AB 32 – Greenhouse Gas Emissions
Joint Meetings of CEC & CPUC.

Docket 07-OIIP-01

COMMENTS OF SOUTHERN CALIFORNIA EDISON COMPANY (U 338-E)
REGARDING JOINT CALIFORNIA PUBLIC UTILITIES COMMISSION AND
CALIFORNIA ENERGY COMMISSION STAFF PROPOSAL FOR AN ELECTRICITY
RETAIL PROVIDER GHG REPORTING PROTOCOL

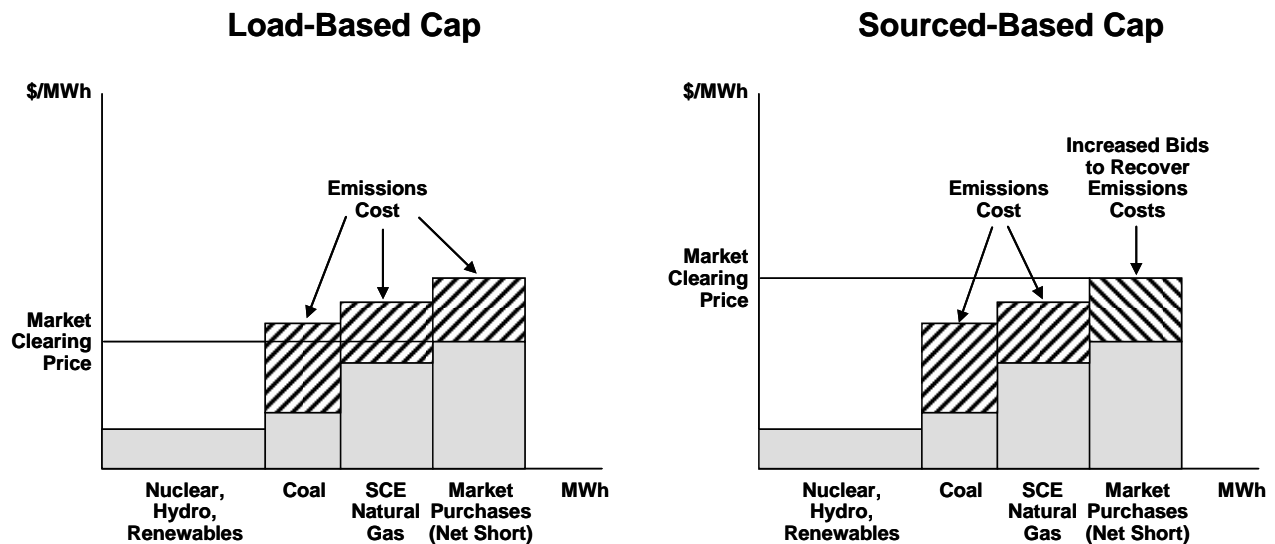
It is important to note that under either a load-based or source-based or First Seller approach, the emissions costs to an LSE will be the same. As shown in the figure below, the total cost to the LSE is the same under either scenario.¹⁹ The difference between the two approaches is how the market responds to GHG emissions regulations in terms of bidding behavior. To better understand the market distortions caused by a load-based approach, a closer examination of the economic features between load-based and source-based or First Seller approaches is required.

First, consider transactions by a non-LSE generator under a load-based approach. The generator sees no change in market prices, as seen in the figure above, because prices will still be set at the marginal cost of generation. Nor does the generator incur increased costs because the LSE is responsible for the cost of emissions. However, a “clean” generator can provide value to an LSE subject to a load-based approach because the LSE will not incur any additional emissions

Under a source-based or First Seller approach the emission costs are internalized for generators (see the figure above), and the market clearing price reflects this economic adjustment. Regardless of how clean or dirty a generator is, they will receive the market clearing price. In this scenario, there is no incentive (or disincentive) for the generator to enter into a bilateral agreement with an LSE and there are no resulting market distortions. It is important to note that the total costs an LSE incurs in either case is represented by the shaded sections in the figure above, with the gray areas illustrating the operating costs, and the hatched areas representing the emissions costs that either increase the direct cost to the LSE (under a load-based approach) or increase the market purchase cost to the LSE (under a source-based or First Seller approach). The total cost the LSE would incur and pass on to retail customers in either a load or source-based approach is the same.
